COOPER NUCLEAR STATION

AMENDMENT TO FACILITY OPERATING LICENSE

Amendment No. 67  
License No. DPR-46

SUPPORTING AMENDMENT NO. 67 TO LICENSE NO. DPR-46

Figure 3.11-1.1 Maximum Average Planar Linear Heat Generation Rate versus Exposure with LPCI Modification and Bypass Flow Holes Plugged, Initial Core Fuel Type 3.

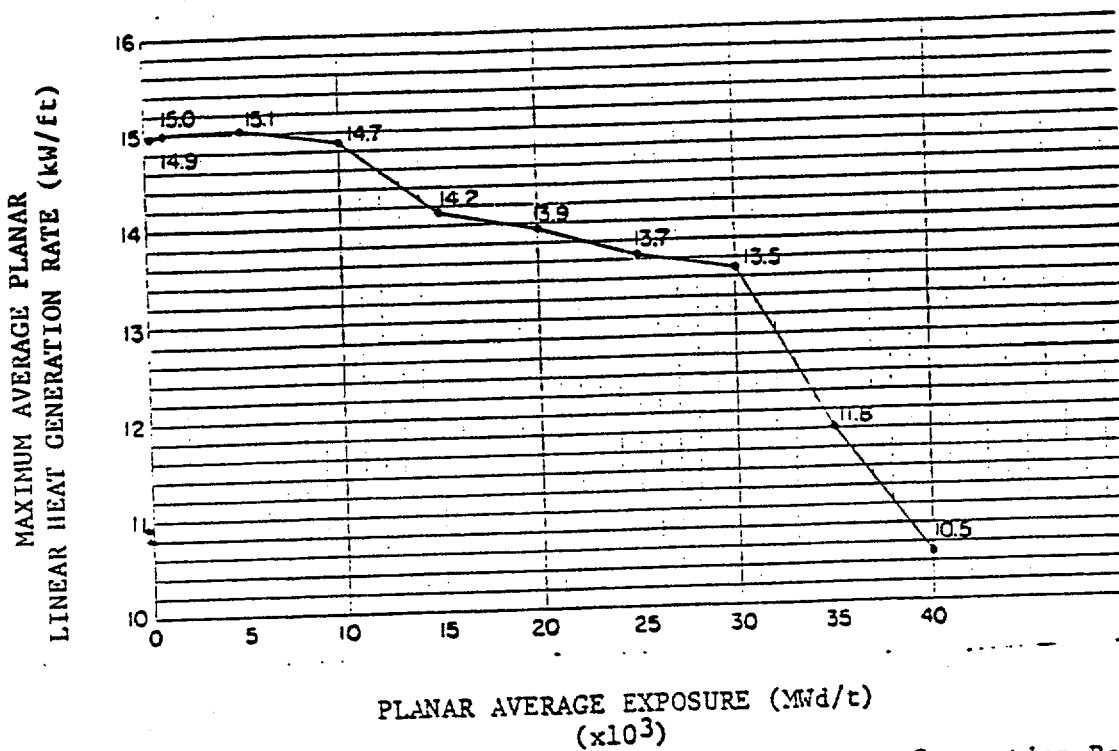
In order to extend the MAPLHGR versus average planar exposure range to 40,000 MWd/t for the subject 7x7 and 8x8 fuel assemblies, higher exposure points are being added by the licensee which were generated using the same methodology of NEDO-24045 which was previously approved for average planar exposures up to 30,000 MWd/t in Reference 3. Although the methodology used is generally applicable for an average planar exposure up to 40,000 MWd/t, the staff believes the effects of enhanced fission gas release in high burnup fuel (above 30,000 MWd/t) are not adequately accounted for in your submittals. To compensate for this deficiency, the staff has estimated the amount the MAPLHGR limits in Figures 3.11-1.1 to 3.11-1.4 of the proposed Technical Specifications should be reduced to assure the peak cladding temperature and local oxidation are below the limits allowed by 10 CFR 50.46. The reduction imposed is based on the results of comparative calculations of fuel volume average temperature performed by General Electric using GEGAP III with and without an NRC correction for enhanced fission gas release and the relationship between peak cladding temperature and MAPLHGR increase presented in NEDE-23786-1-P.(4). In estimating the MAPLHGR reduction, the staff conservatively assumed the change in volume average temperature can be translated directly into a peak cladding temperature change. Table 1 gives the percent reduction in MAPLHGR as a function exposure above 30,000 MWd/t for the 7X7 (types 2 and 3) and 8x8 (types 8D250 and 8D2741) fuel in your submittals. We have limited the extension of the MAPLHGR to 36,000 MWd/t to account for the uncertainties in enhanced fission gas release above this exposure.

These MAPLHGR reductions to the licensee's proposed Technical Specifications in Figures 3.11-1.1 to 3.11-1.4 assures that the cladding temperature and local cladding oxidation would remain below the 2200°F (peak cladding temperature) and 17% (local cladding oxidation) limit allowed by 10 CFR 50.46 when the effects of enhanced fission gas release above 30,000 MWd/t are conservatively accounted for.

Exposure MWd/t	30,000	32,000	34,000	36,000
Reduction MAPLHGR, %	9.0	12.5	16.25	20.5

The licensee has agreed to the reductions in MAPLHGR limits given in Table 1 and to the 36,000 MWd/t exposure limit as per discussions on January 27, 1981. These limitations are applicable for the remainder of Cycle 6 only. For subsequent cycles, the licensee proposed MAPLHGR values for the fuel types identified in Figures 3.11-1.1 to 3.11-1.4 are applicable only up to an exposure of 30,000 MWd/t. Accordingly, we find the proposed MAPLHGR versus average planar exposure values acceptable if modified as stated.
